Subject: FW: Kensington Road abandonment
Date: Wednesday, February 5, 2020 at 8:38:25 AM Eastern Standard Time
From: Panjshiri, Atiq
To: McCray, Tiara
CC: Terry, Mark, Torma, Rebecca, Pallas, Edward, LaBaw, Marie, Hanley, Kyle K., Funderburk, Kim C.
Category: Important / Action Item
Attachments: image001.jpg, image003.jpg, image005.jpg

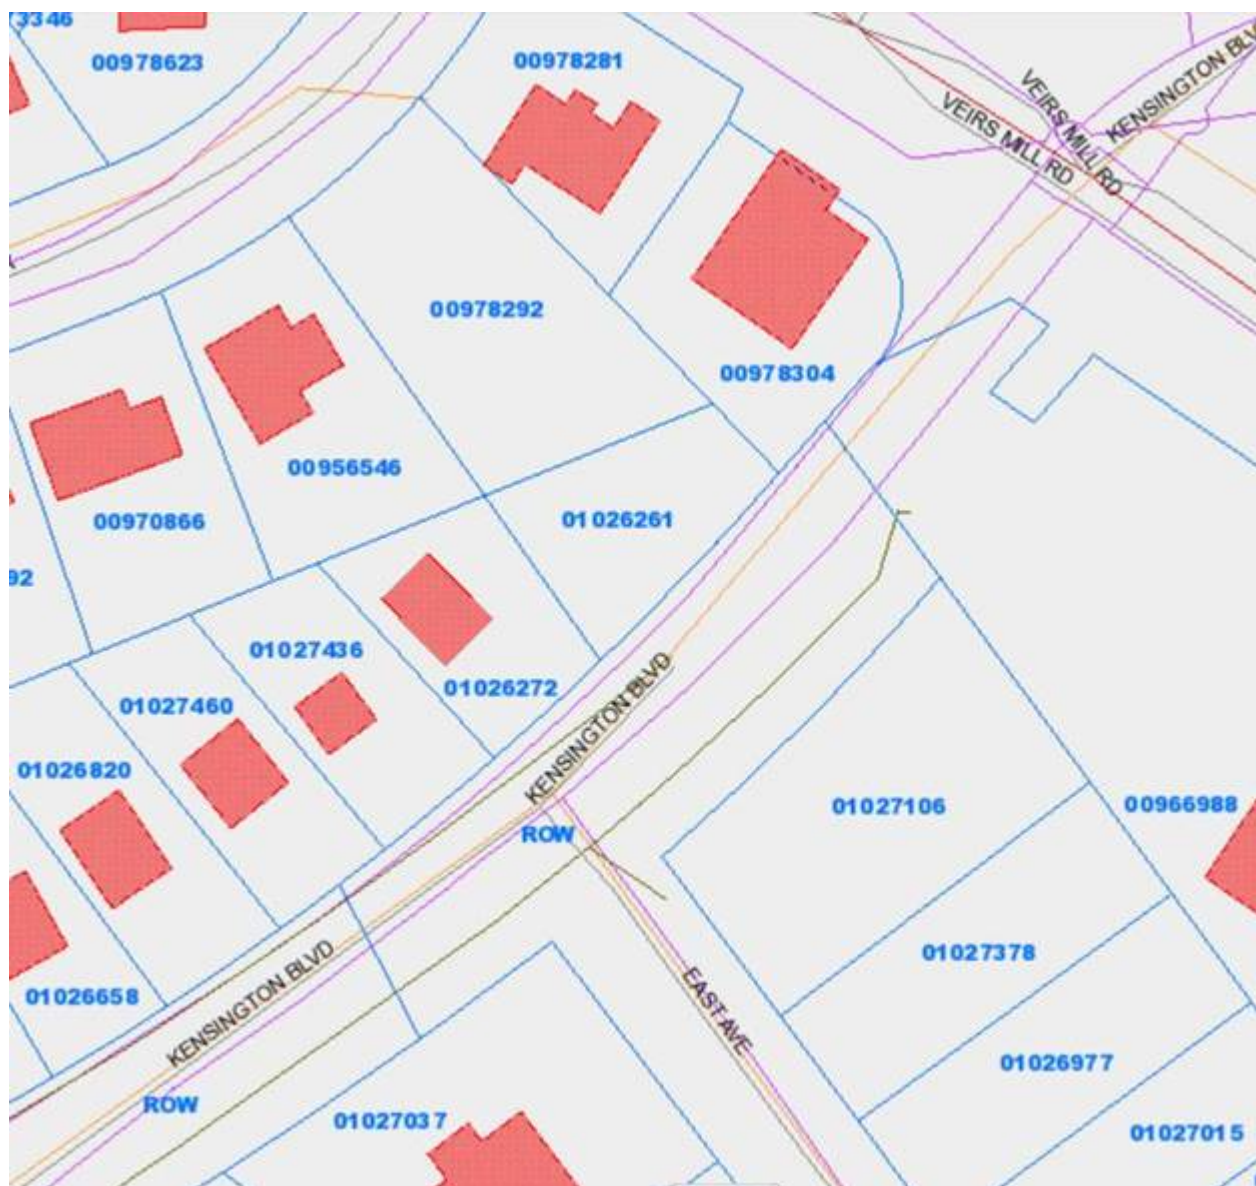
We DO NOT recommend abandonment of Kensington Blvd. There are two parallel Storm Drain as well as water and Sewer main within the Right of way (see the GIS map below).

Here is a snip of our GIS map of the area showing to 2 storm drain lines and water and sewer lines
